From: Bryan, James <james.bryan@kimley-horn.com>
Sent: Friday, May 17, 2024 8:12 AM
To: Newin, Duke D; Lemoine, Matt
Subject: RE: WC-1043

Subject: WC-1043

From: Bryan, James <james.bryan@kimley-horn.com>
Sent: Friday, May 24, 2024 4:04 PM
To: Newin, Duke D <duke.newin@okc.gov>; Lemoine, Matt <matt.lemoine@okc.gov>
Subject: WC-1043 AM1/CO1 Revised

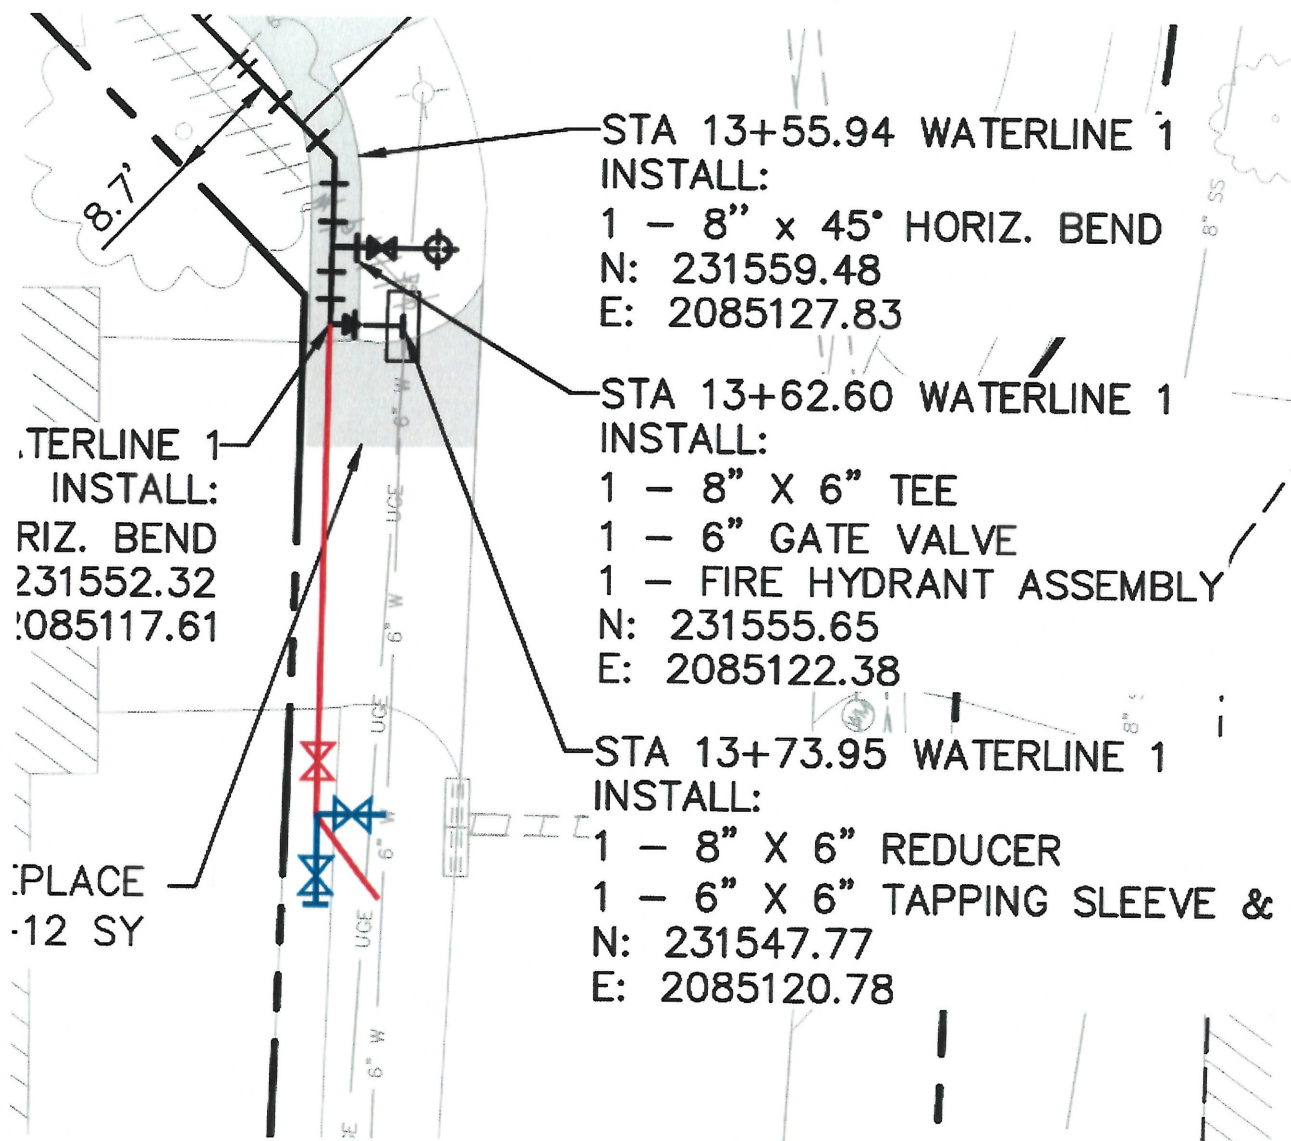
The blue option with an additional valve for future extension makes sense. Future replacement is foreseeable due to the pipe condition.

The contractor does not recommend doing another tap on the existing line due to its condition. There was another break on the existing line yesterday a little further south of the driveway. The existing line seems to be pretty brittle at this point, so tapping it is not advised. They also don't recommend reusing the tapping sleeve, as the gasket can be compromised and they aren't rated for multiple installations. The valve could be re-used though. Below is a quick markup of a couple options for this connection. The first one (red option) is the simplest and cheapest, but would require a shutdown in the future to extend (essentially no different than the original design). The second one (blue option) is more robust and would allow for future extension without a shutdown, but requires an extra valve. Either option will work and the contractor is fine installing either one.

See below for a picture from today regarding the leak at 4800 NW 161st as well as marked up drawings with our proposal on what to do moving forward.

I marked up the plans with our teams proposal on what we are thinking needs to take place to provide the city and customers with the best product possible. We do not want to leave that wrap around under this driveway and this proposal would eliminate that. Please advise.

Remove 90° tapping
sleeve and valve.

2- 8" x 45 Bends
8" Gate Valve
8" x 6" Reducer
6" Wet Connection

Please proceed.
